Well Name	Well Number	US Well Number	Lease Number	Case Number	Operator
RED BULL 29 20	103H	3002554350	NMNM117558	NMNM117558	DEVON
RED BULL 29 20	104H	3002554351	NMNM117558	NMNM117558	DEVON
RED BULL 29 20	203H	3002554354	NMNM117558	NMNM117558	DEVON
RED BULL 29 20	204H	3002554355	NMNM117558	NMNM117558	DEVON

Notice of Intent

Type of Action: APD Change

Procedure Description: Engineering Only - Devon Energy Production Company L.P. respectfully requests the following changes to the approved APD: Offline BOP/Stump testing variance request. Batched wells on Red Bull 29 Wellpad 2. Please see attached Break Test Variance_Offline BOP variance request document.

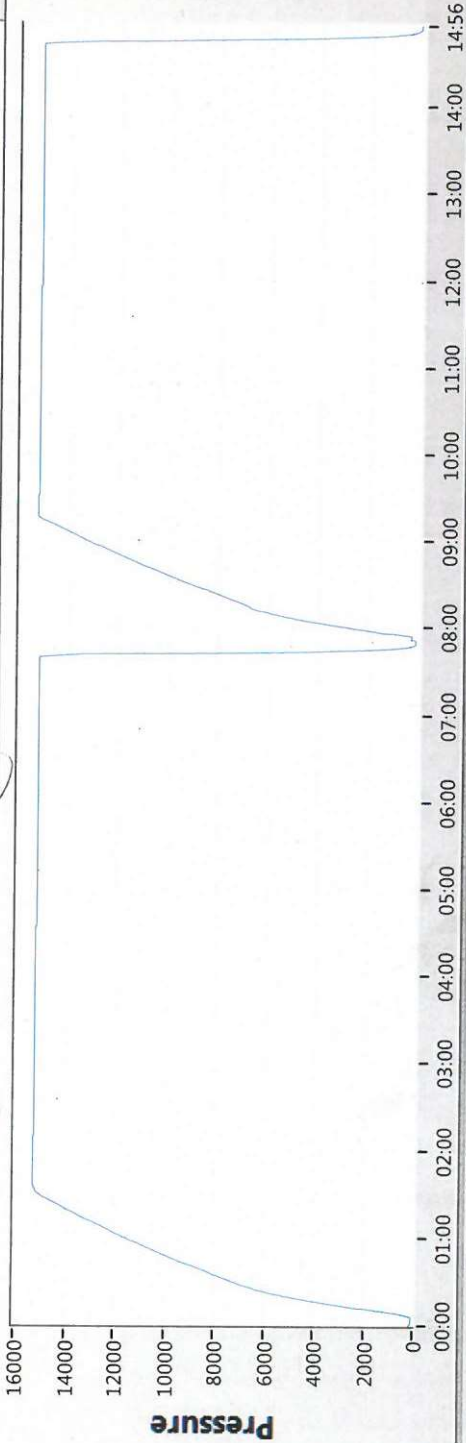
Devon Energy requests to only test BOP connection breaks after drilling out of surface casing and while skidding between wells which conforms to API Standard 53 and industry standards. The initial BOP test will follow 43 CFR 3172, and subsequent tests following a skid will only test connections that are broken. This test will at minimum include the Top Pipe Ram, HCR, Kill Line Check Valve, QDC (quick disconnect to wellhead) and BOP shell of the 10M BOPE to 5M for 10 minutes. Additional pressure testing is required for pressure-containing and pressure-controlling connections when the integrity of a pressure seal is broken. If a break to the flex hose that runs to the choke manifold is required due to repositioning from a skid, the HCR will remain open during the shell test to include that additional break. The variance only pertains to intermediate hole-sections. This variance will meet or exceed 43 CFR 3172 per the following: Devon Energy will perform a full BOP test per 43 CFR 3172 before drilling out of the intermediate casing string(s) and starting the production hole, testing the Annular during initial BOP testing to a minimum of 70% RWP and higher than MASP, and pressure testing at a 21-day interval frequency. The BLM will be contacted 4hrs prior to a BOPE test. The BLM will be notified if and when a well control event is encountered. In the event break testing is not utilized, then a full BOPE test would be conducted.

Devon Energy requests to perform offline BOP stump testing and offline BOPE testing. All pressure-containing and pressure-controlling seals will be tested either online or offline as denoted in the table below and per BLM approval during initial BOP test following test pressure requirements set forth in 43 CFR 3172. Remaining components not tested offline or on the stump will be tested within 72-hours when the BOP is connected to the wellhead. If stump testing exceeds 72-hour window prior to connecting to the wellhead, the BLM will be notified and either stump testing restarted, or the BOP being tested online. The BLM will be contacted 4hrs prior to a BOPE test. The BLM will be notified if and when a well control event is encountered. In the event stump testing is not utilized, then a full BOPE test would be conducted.

Devon requests offline BOPE testing for the following components: Upper Rams, Blind Rams, Kill Valves, Choke Valves, and Annular

Devon requests Break testing as stated above for SK tests, not including production hole

Annular Preventer will be tested to minimum of 70% RWP and higher than MASP during initial BOP test

Pressure testing is required for pressure-containing connections if the integrity of a pressure seal is broken during a break test

All Previous COAs Still Apply. Variance request procedure is approved as written, please see below general conditions for variance.

- BOPE Break Testing is ONLY permitted for 5M BOPE or less. **(Annular preventer must be tested to a minimum of 70% of BOPE working pressure and shall be higher than the MASP)**

- BOPE Break Testing is NOT permitted to drilling the production hole section.
- Variance only pertains to the intermediate hole-sections and no deeper than the Bone Springs formation.

Operator has been **(Approved)** to test the BOPE offline.

The BOPE offline testing shall be stationary during pressure testing.

Online BOPE testing should commence within 72 hours of offline BOPE testing completion. Notify the BLM if interval exceeds 72 hours.
